Mr Mee Access table prepared by Peter Cole of Ceres Property

Accesses - Retained Land Affected by Lower Thames Crossing

PLAN 1

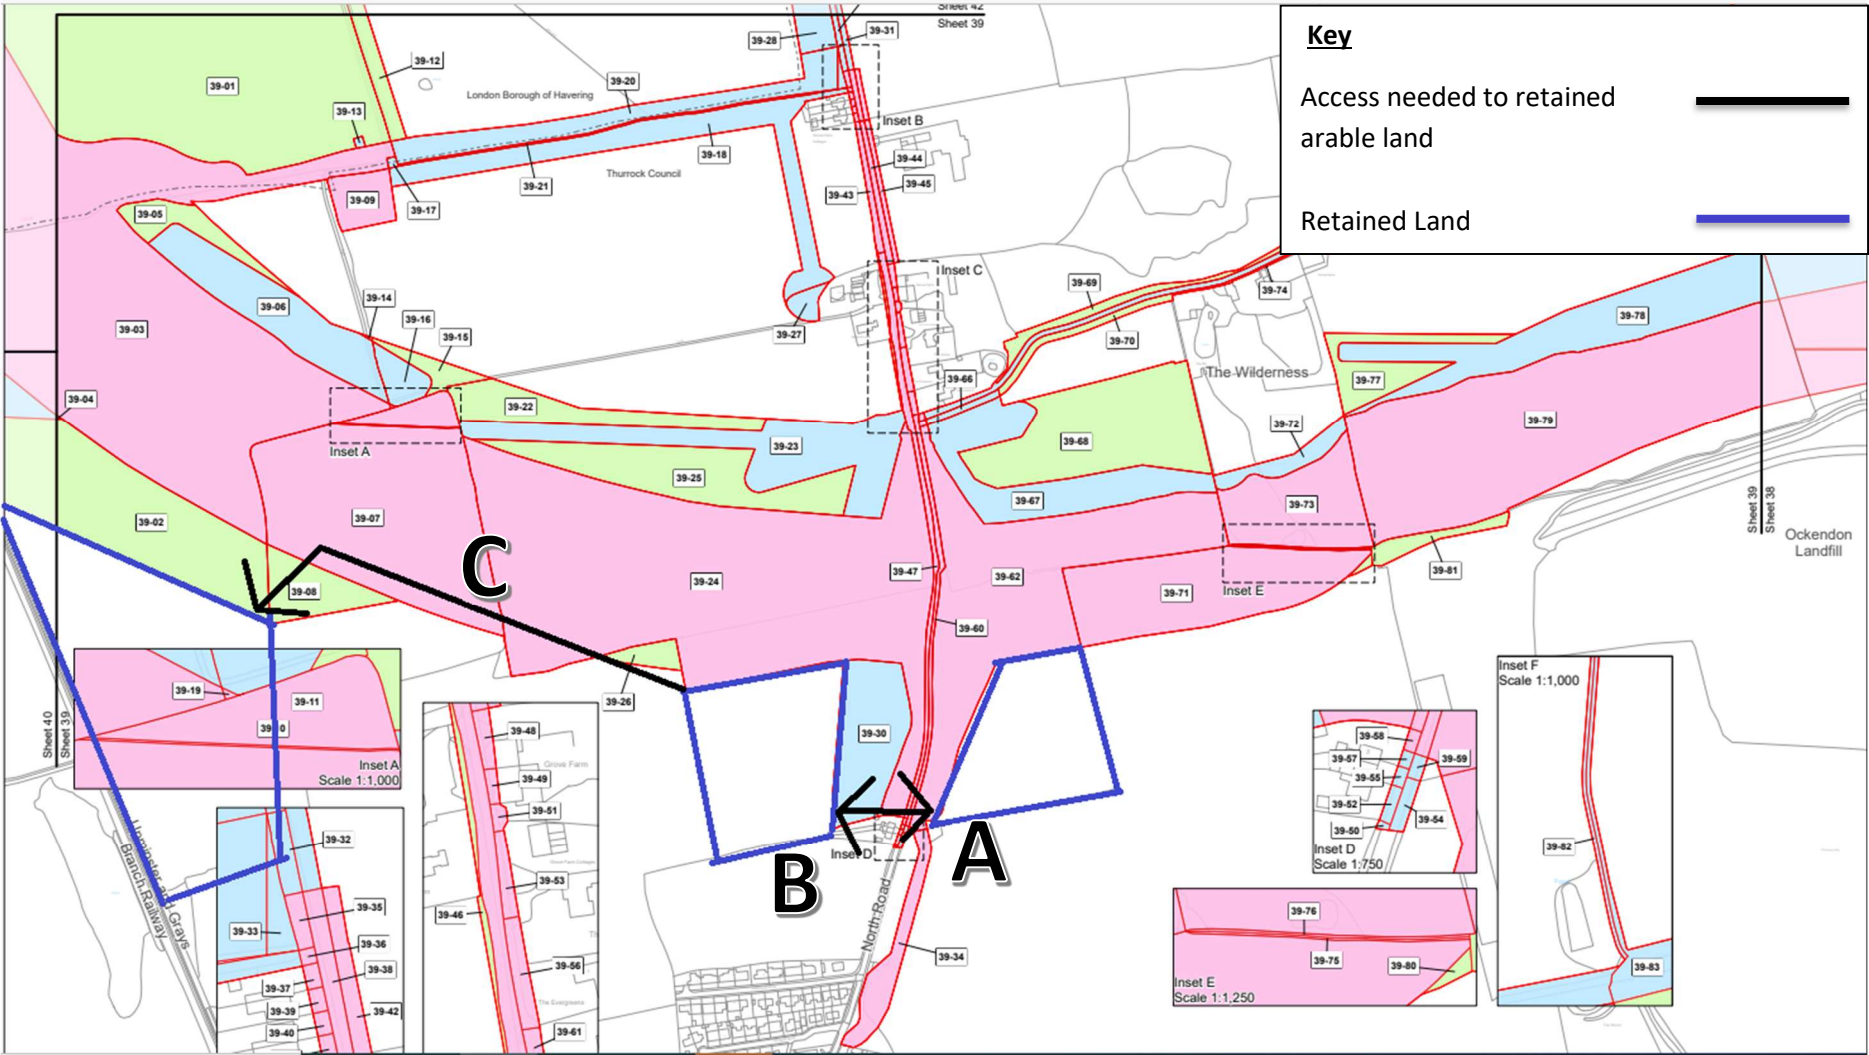
Applicant's Plan which has been annotated by Peter Cole	Plan 1	Plan 1	Plan 1
Current Access	Mr Mee's current access to the field outlined in purple is from the arable field to the north.	Mr Mee's current access to the field outlined in purple is currently from the arable field to the north.	Mr Mee's current access to the field outlined in purple is currently from the arable field to the north.
Applicant's proposed replacement access to allow continued use of retained arable land	Point A on the above plan	Point B on the above plan	Point C on the above plan but not provided by the Applicant.
Description of Applicant's proposed replacement access	There is an existing access where the Applicant proposes to provide its replacement access which is Approx 3 metres in width	There is an existing access where the Applicant proposes to provide its replacement access which is Approx 4 metres in width	Access is barred

Effects of LTC Scheme, and comments on the suitability of replacement access	Lower Thames Crossing will sever the current access. There is an existing access to the arable land from North Road at "Point A" which the Applicant has proposed as the main access point to the arable land. A new WCH is also proposed that will interact with this access, and	Lower Thames Crossing will sever the current access. There is an existing access from North Road at "Point B" which the Applicant has proposed as the main access point to the arable land.	Lower Thames Crossing will sever the current access. There is no designed access to this retained land and access is barred

<p>it will be used as a maintenance track by the Applicant.</p> <p>Applicant’s proposed access is not suitable:</p> <ol style="list-style-type: none"> 1. For safety reasons with the interaction with vehicles using North Road. 2. The access is currently not wide enough nor suitable for modern agricultural equipment. 3. It will not prevent unauthorised access. 	<p>Applicant proposed access is not suitable:</p> <ol style="list-style-type: none"> 1. For safety reasons with the interaction with vehicles using North Road. 2. The access is currently not wide enough nor suitable for modern agricultural equipment. 3. It will not prevent unauthorised access. 	
Photo from Roadside			
Orientation of Photo	Looking east into “Point A”	Looking west into “Point B”	N/A
Result of lost access	The Applicant is trying to utilise an existing access as a replacement but what is currently there is not suitable and without improvements, Mr Mee cannot farm the land.	The Applicant is trying to utilise an existing access as a replacement but what is currently there is not suitable and without improvements, Mr Mee cannot farm the land.	There is no access provided by the Applicant. Without one Mr Mee cannot farm the land.

<p>Mr Mee's need for new access</p>	<p>Access to this land is required of at least 5 metres in width and suitable for a turning circle to cater for farm vehicles and machinery (e.g. combine and tractor and trailers). This may need to be wider to comply with highway safety requirements i.e the need for visibility splays to ensure that it is safe.</p> <p>Access to the land will need to provide suitable security measures i.e. a reinforced gate with poacher blocks to prevent unauthorised access.</p> <p>It is the case in this part of south Essex, near to a large urban conurbation and easy main routes of road access that the pressure from unauthorised users is evidently of such a degree that when barriers have been used, they have been damaged.</p> <p>We are unaware of how often this access track will be used by the Applicant for maintenance and if passing bays will need to be provided if this access will be shared. It is unclear how the WCH will interact with the agricultural access as we don't know the design requirements of the WCH.</p>	<p>Access to this land is required of at least 5 metres in width and suitable for a turning circle to cater for farm vehicles and machinery (e.g. combine and tractor and trailers). This may need to be wider to comply with highway safety requirements i.e the need for visibility splays to ensure that it is safe.</p> <p>Access to the land will need to provide suitable security measures i.e. a reinforced gate with poacher blocks to prevent unauthorised access.</p> <p>It is the case in this part of south Essex, near to a large urban conurbation and easy main routes of road access that the pressure from unauthorised users is evidently of such a degree that when barriers have been used, they have been damaged.</p> <p>Any works to the Applicant's proposed access location will need to interact with the existing electricity pole and footpath adjacent to the access.</p>	<p>The Applicant needs to provide an access from "Point A" from North Road. This will need to be at least 5 metres in width and suitable for a turning circle to cater for farm vehicles and machinery (e.g. combine and tractor and trailers). This may need to be wider to comply with highway safety requirements i.e the need for visibility splays to ensure that it is safe.</p> <p>Access from North Road at "Point A" will need to provide suitable security measures i.e. a reinforced gate with poacher blocks to prevent unauthorised access.</p> <p>The access route will be over third party land. Mr Mee will need specific rights.</p> <p>The Applicant needs to provide an access track which is at least 5 metres in width from "Point A" to connect into this land. If the access track is to be shared with the Applicant we need to know how often this access track will be used for maintenance and if passing bays will need to be provided if this access will be shared.</p>

Overall conclusions on Applicant Proposal for access	<p>Applicant has suggested an alternative access using an existing access from North Road.</p> <ol style="list-style-type: none">1. There is no detailed design on the specifications requested above.2. There is no detail on for a shared access between the Applicant and our Client and there should be no conflict between access for maintenance and to use the land for farming.3. There is no detailed design on the how the WCH will interact with the access and how unauthorised access can be prevented.	<p>In their current designs, the Applicant has suggested an alternative access using an existing access from North Road, but we have the following observations:</p> <ol style="list-style-type: none">1. There is no detailed design on the specifications requested above.2. There is no detail on shared access between the Applicant and our Client and there should be no conflict between access for maintenance and to use of the land for farming.	<p>In their current designs, the Applicant has not provided an access to this land. The Applicant will need to provide:</p> <ol style="list-style-type: none">1. An access to this land in line with the specifications requested above.2. Detailed design on the specification requested above3. There is no detail on a shared access between the Applicant and our Client and there should be no conflict between access for maintenance and to use the land for access to farm the arable field.

PLAN 2

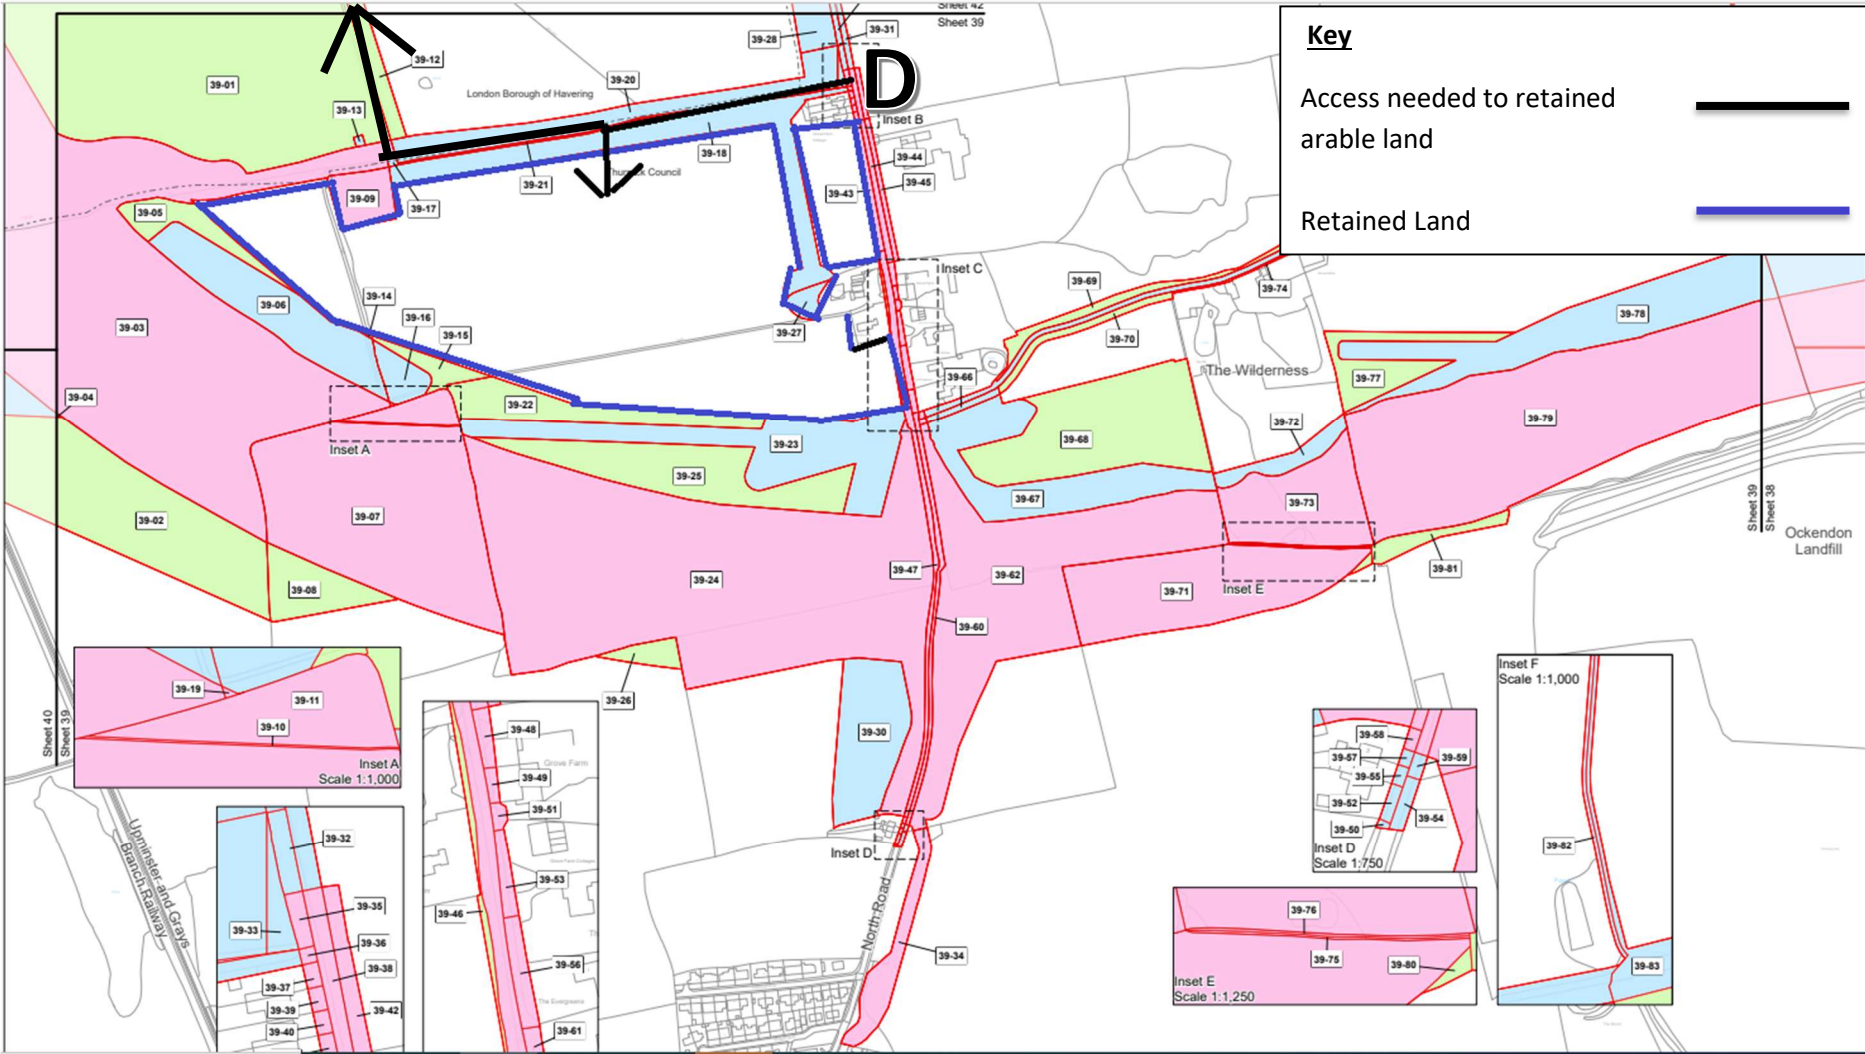
Applicant's Plan which has been annotated by Peter Cole	Plan 2	Plan 3	Plan 4
Current Access	Access to the field outlined in purple is currently taken from North Road by "Redcroft Forge", further south and over the arable fields.	Access to the field outlined in purple is currently taken from North Road by "Redcroft Forge", further south and over the arable fields.	Access to the field outlined in purple is currently taken from Ockendon Road, over the arable field known has Hobbs Hole Field and over Pike Lane.
Applicant's proposed replacement access to allow continued use of retained arable land	Point D on the above plan	Point E on the above plan	Point F on the above plan but not provided by the Applicant.
Description of Applicant's proposed replacement access	There is an existing access where the Applicant proposes to provide its replacement access which is Approx 4 metres in width	There is an existing access (entrance of Church Lane) where the Applicant proposes to provide its replacement access which is Approx 14 metres in width	Access is barred

Effects of LTC Scheme, and comments on the suitability of replacement access	<p>Lower Thames Crossing will sever the current access through the arable fields.</p> <p>There is an existing access to the arable land from North Road at "Point D" which the Applicant has proposed as the main access point to the arable land. A new WCH is also</p>	<p>Lower Thames Crossing will sever the current access through the arable fields.</p> <p>There is an existing access from Ockendon Road at "Point E" which the Applicant has proposed as the main access point to the arable land.</p>	<p>Lower Thames Crossing will sever the current access.</p> <p>There is no designed access to this retained land and access is barred.</p> <p>Access up Pike Lane is not suitable for</p>

<p>proposed that will interact with this access, and it will be used as a maintenance track by the Applicant.</p> <p>Applicant’s proposed access is not suitable:</p> <ol style="list-style-type: none"> 1. For safety reasons with the interaction with vehicles using North Road and the property known as 4 Groves Farm Cottages. 2. The access is currently not wide enough nor suitable for modern agricultural equipment. 3. It will not prevent unauthorised access. 	<p>Applicant’s proposed access is not suitable:</p> <ol style="list-style-type: none"> 1. For safety reasons as Church Lane does not provide a suitable width for agricultural equipment because of residents parking their vehicles on the roadside. 	<p>agricultural equipment with the width restrictions and crossing over the Railway bridge. Access down Pike Lane is not suitable for agricultural equipment with the width restrictions and the distance from the farmstead.</p>

<p>Mr Mee's need for new access</p>	<p>Access to this land is required of at least 5 metres in width and suitable for a turning circle to cater for farm vehicles and machinery (e.g. combine and tractor and trailers). This may need to be wider to comply with highway safety requirements i.e the need for visibility splays to ensure that it is safe.</p> <p>Access to the land will need to provide suitable security measures i.e. a reinforced gate with poacher blocks to prevent unauthorised access.</p> <p>It is the case in this part of south Essex, near to a large urban conurbation and easy main routes of road access that the pressure from unauthorised users is evidently of such a degree that when barriers have been used, they have been damaged.</p> <p>We are unaware of how often this access track will be used by the Applicant for maintenance and if passing bays will need to be provided if this access will be shared. It is unclear how the WCH will interact with the agricultural access as we don't know the design requirements of the WCH.</p>	<p>Should "Point E" be used, then Church lane would need to be widened to accommodate agricultural equipment and allow residents to park their vehicles on the roadside.</p> <p>The Applicant needs to provide an access from "Point D" from North Road. This will need to be at least 5 metres in width and suitable for a turning circle to cater for farm vehicles and machinery (e.g. combine and tractor and trailers). This may need to be wider to comply with highway safety requirements i.e the need for visibility splays to ensure that it is safe. Access from North Road at "Point D" will need to provide suitable security measures i.e. a reinforced gate with poacher blocks to prevent unauthorised access.</p> <p>The Applicant needs to provide an access track which is at least 5 metres in width from "Point D" to connect into this land. If the access track is to be shared with the Applicant we need to know how often this access track will be used for maintenance an construction and if passing bays will need to be provided if this access will be shared.</p>	<p>Access to this land at "Point F" is required of at least 5 metres in width and suitable for a turning circle to cater for farm vehicles and machinery (e.g. combine and tractor and trailers). This may need to be wider to comply with highway safety requirements i.e the need for visibility splays to ensure that it is safe.</p> <p>Access to the land will need to provide suitable security measures i.e. a reinforced gate with poacher blocks to prevent unauthorised access.</p> <p>It is the case in this part of south Essex, near to a large urban conurbation and easy main routes of road access that the pressure from unauthorised users is evidently of such a degree that when barriers have been used, they have been damaged.</p> <p>We are unaware of how often this access track will be used by the Applicant for maintenance and if passing bays will need to be provided if this access will be shared.</p>

<p>Proposal for access</p>	<ol style="list-style-type: none"> 1. There is no detailed design on the specifications requested above. 2. There is no detail on for a shared access between the Applicant and our Client during construction and there should be no conflict with use of the track to allow the land to be farmed. 3. There is no detailed design on the how the WCH will interact with the access and how unauthorised access can be prevented. 	<ol style="list-style-type: none"> 1. There is no detailed design on the specifications requested above. 2. Mr Mee would need to use "Point D" and can not use "Point E" unless Church Lane is widened. 3. There is no detail on a shared access between the Applicant and our Client during construction and there should be no conflict between access for construction and to use the track to access the land for farming. 	<ol style="list-style-type: none"> 1. An access to this land in line with the specifications requested above. 2. Detailed design on the specification requested above 3. There is no detail on a shared access between the Applicant and our Client and there should be no conflict between access for maintenance and to use the land for access to farm the arable field.
